AUTOMATIC TRANSMISSION SERVICE GROUP

REVISED EDITION

Since the introduction of the THM 440-T4 Transaxle in April, 1984, there have been many major engineering design changes. These changes have affected nearly every part used in the THM 440-T4. This Update Handbook will explain each change, the parts affected by the change, and any parts interchangeability problems created by the change.

Figure 91

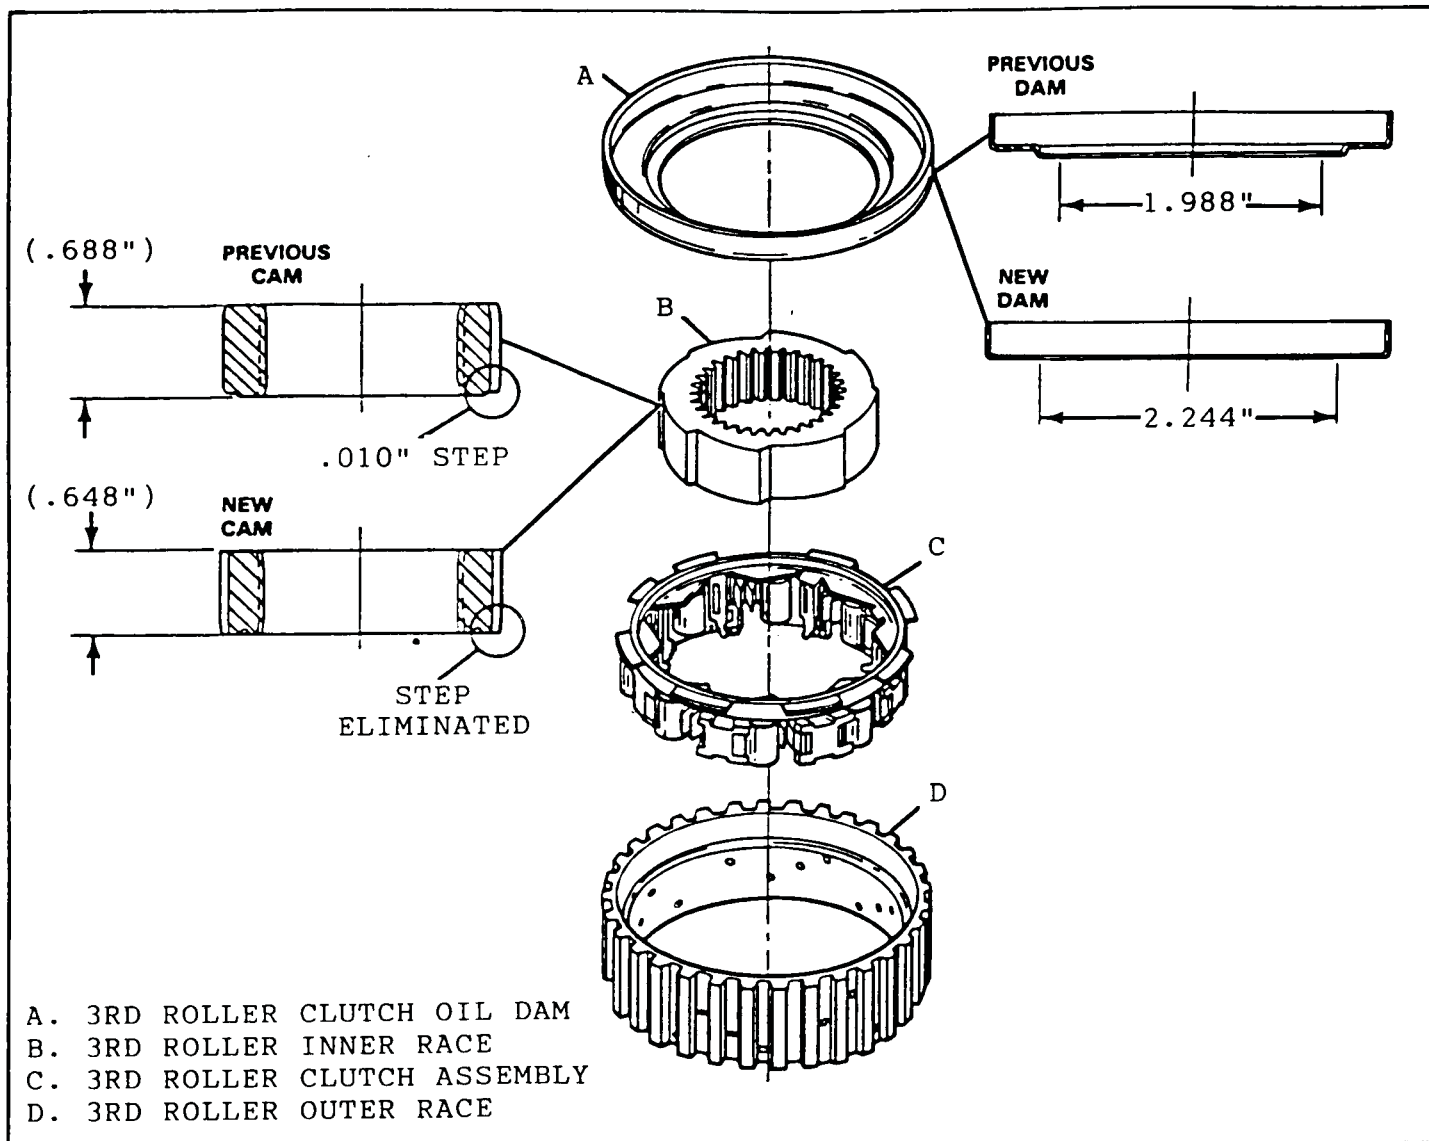
- (1) Input Housing - Surface on the input housing where the new bearing assembly rides, has been reduced by .035" to accommodate the increased thickness of the new bearing (See Figure 90).
- (2) "Top Hat" Thrust Washer - Eliminated (See Figure 90).
- (3) Lock Up Sleeve - The lock up sleeve is no longer needed and has been eliminated (See Figure 90).
- (4) 3rd Roller Clutch Lube Dam - The inside diameter has been increased by .256" to accommodate the larger diameter new bearing, and the lip on the lube dam eliminated for increased lube flow to the 3rd roller assembly (See Figure 91).
- (5) 3rd Roller Clutch Inner Race - Has been machined .040" thinner to accommodate the increased thickness of the new bearing assembly (See Figure 91).

Figure 93

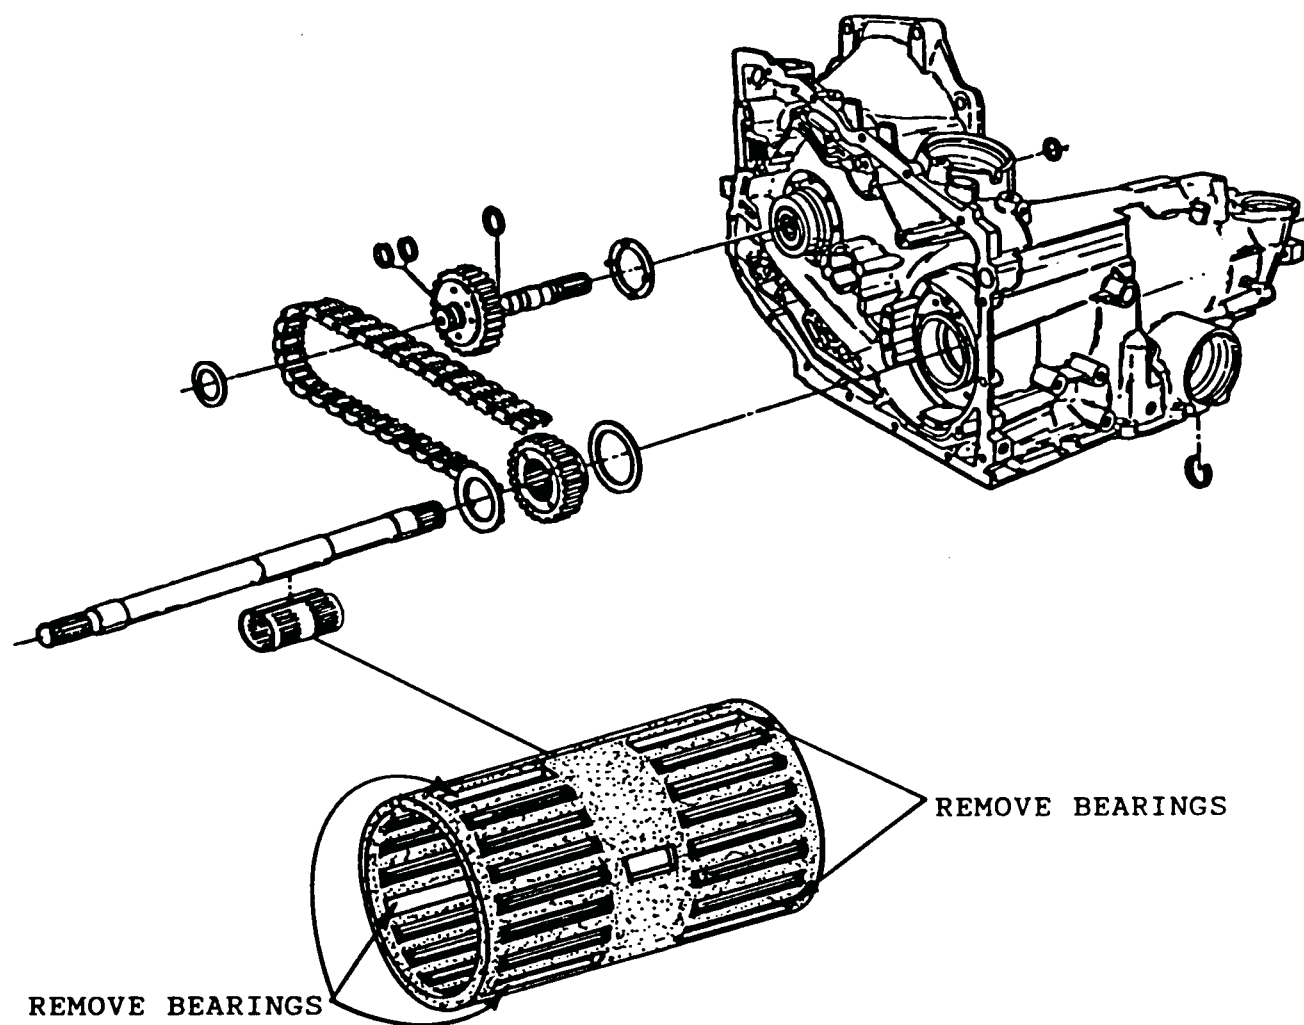
- COMPLAINT: Repeated failure of the 3rd Roller Clutch and/or the Input Sprag Assembly.
- CAUSE: Lack of lube oil to 3rd Roller Clutch and Input Sprag.
- CORRECTION: Modification as follows, of the parts indicated, will increase lube flow to both the 3rd Roller Clutch and the Input Sprag.

REMOVE INDIVIDUAL NEEDLE BEARINGS IN THREE EQUALLY SPACED LOCATIONS AROUND THE BEARING TO PROVIDE THREE "TROUGHES" FOR ADDITIONAL LUBE OIL TO FLOW.

Figure 95

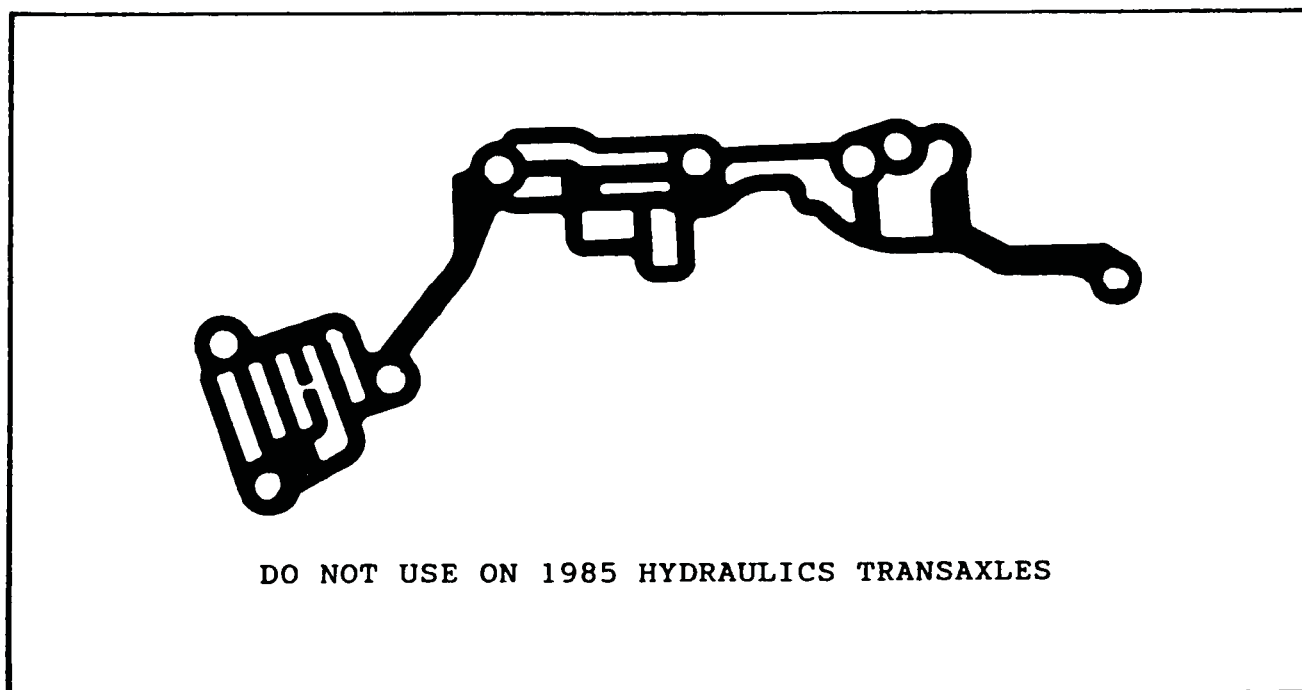
CHANGE: Upper Channel Plate Gasket (See Figure 95).

- (1) Upper Channel Plate Gasket - The Upper Channel Plate Gasket and Modulator Port Gasket are now connected together as one gasket (See Figure 95).

The new design Upper Channel Plate Gasket will most likely "Not Appear" in aftermarket gasket sets, as the previous design gaskets will work fine.

Figure 96

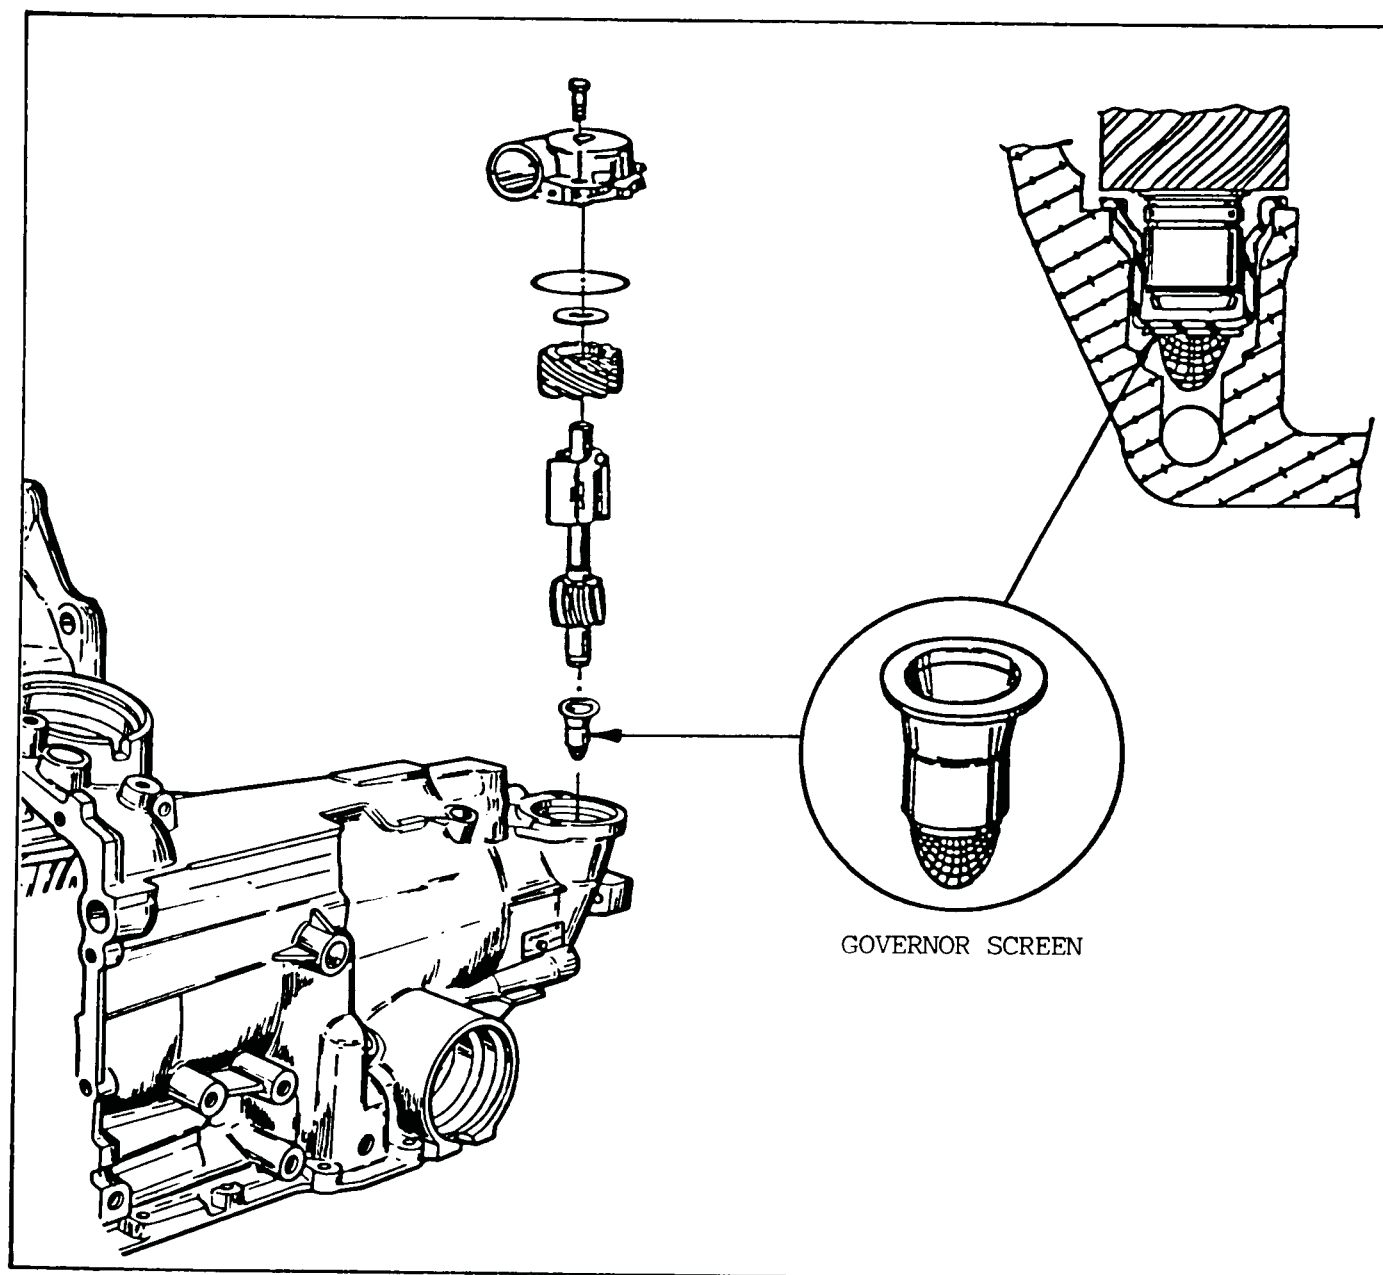
The governor screen was added in 1989 to the governor sleeve in the case, to minimize the possibility of sediment entering the governor assembly and preventing the governor balls from seating properly. (See Figure 96).

A machining change was necessary in the case to make room for the new governor screen, thus it will not retro fit to previous models.
